Product Change Notice

PCN#: EE-PCN16034

Maximum height dimension (Hmax) is shown incorrectly on the datasheet.

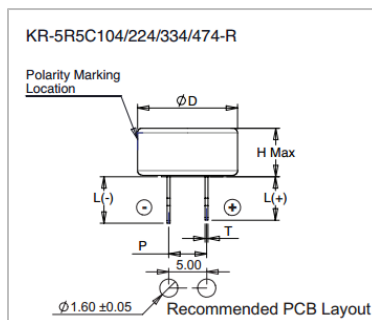
Hmax from 6.4mm to 6.5mm

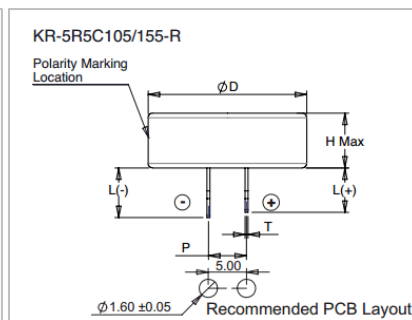
Hmax from 6.9mm to 7.1mm

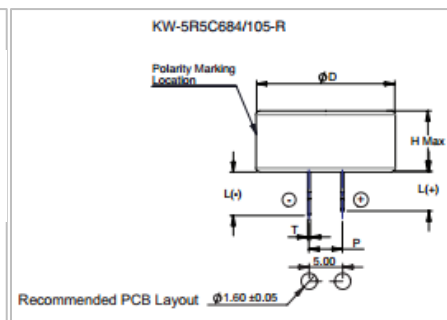
Hmax from 8.70mm to 8.85mm
